SUMMARY OF CONCERNS IN RELATION TO THE PROPOSED NORTHCONNEX TUNNEL

This is an objection to many aspects of the proposed NorthConnex tunnel.

SECTION A: THE CONNECTIVITY OF NORTHCONNEX SOUTHERN VENTILATION FACILITY AT THE SOUTHERN INTERCHANGE, THE SOUTHBOUND TUNNEL IN PARTICULAR

MOTORWAY OPERATIONS COMPLEX - SOUTHERN VENTILATION FACILITY - SECTIONS
M1-M2-5000-DR-JD-0525

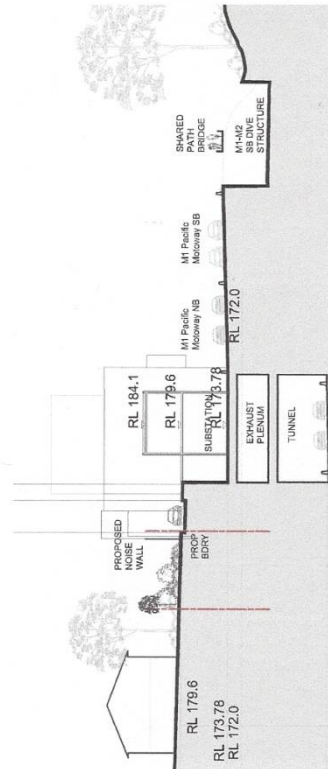
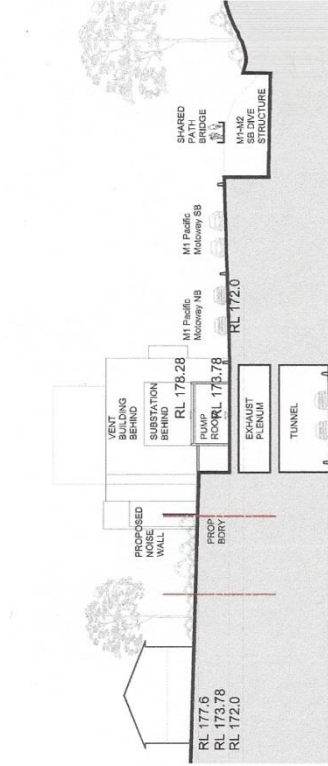
5. *EIS Volume 4, Technical working papers - Urban Design, 6.0 Operational Ancillary Facilities*
EIS Page 99 there is the diagram "Motorway Operations Complex – Southern Ventilation Facility – sections. *Page 10 below* The diagram has the cryptic label "Connection to tunnel TBC". What does TBC stand for? To be considered? Why is tunnel singular? Which tunnel is the diagram referring to northbound or southbound? There is no diagram showing any connection from the Southern Interchange ventilation facility to either the northbound or the southbound tunnel in any way AND YET

- Diagrams need to be provided showing the inter-relation between the shaft, the ventilation outlet and the motorway operations centre with a clear description of what is to be constructed and how it will operate.
- The community needs irrefutable evidence that the polluted air from the southbound tunnel exit portals will not be allowed to flow like an invisible sewer through West Pennant Hills, North Rocks, Carlingford and Beecroft.

M1-M2-5000-DR-UD-0556
NORTHERN VENTILATION FACILITY - LONG SECTION

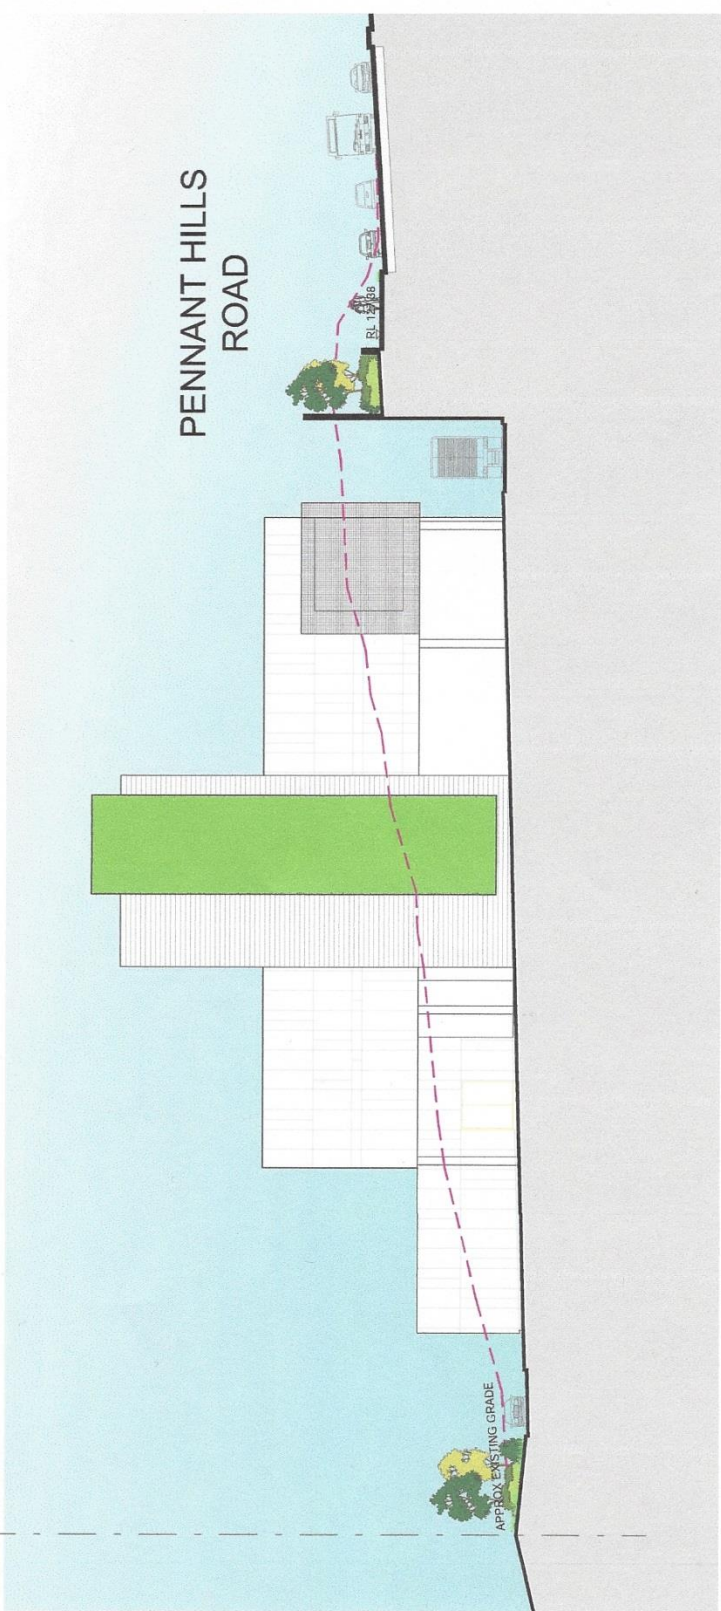
EIS page 135 *Page 11 below* there is a very explicit diagram showing the *Northern Ventilation Facility – cross section*.

EIS page 134 *Page 12 below* there is a very explicit diagram showing the *Northern Ventilation Facility – long section*.

Why are there no comparable diagrams for the Southern Interchange and the Southern Ventilation facility?

MOTORWAY OPERATIONS COMPLEX - SOUTHERN VENTILATION FACILITY - SITE SECTION 1-1
 M1-M2-5000-DR-UD-0713

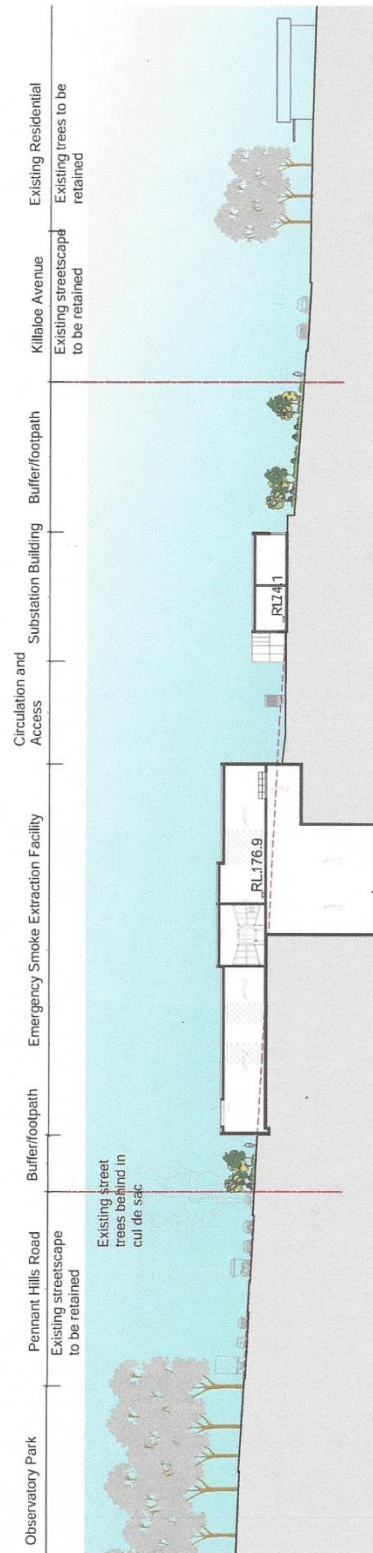
6. *EIS Volume 4, Technical working papers Urban Design, 8.0 Landscape Design*
EIS Page 176 is the diagram "Motorway Operations Complex – Southern Ventilation Facility – Site 1-1". *Page 13 below* The diagram does not show any connection to either the northbound or southbound tunnel. In the same Landscape Design section, EIS Page 182 is the diagram "Wilson Road Tunnel Support Facility –Section" *Page 14 below* which clearly shows the connection to the tunnels. In the same Landscape Design section, EIS Page 189 is the diagram "Northern Ventilation Facility – Landscape Concept Section". *Page 15 below* This also clearly shows the connection to the tunnels.
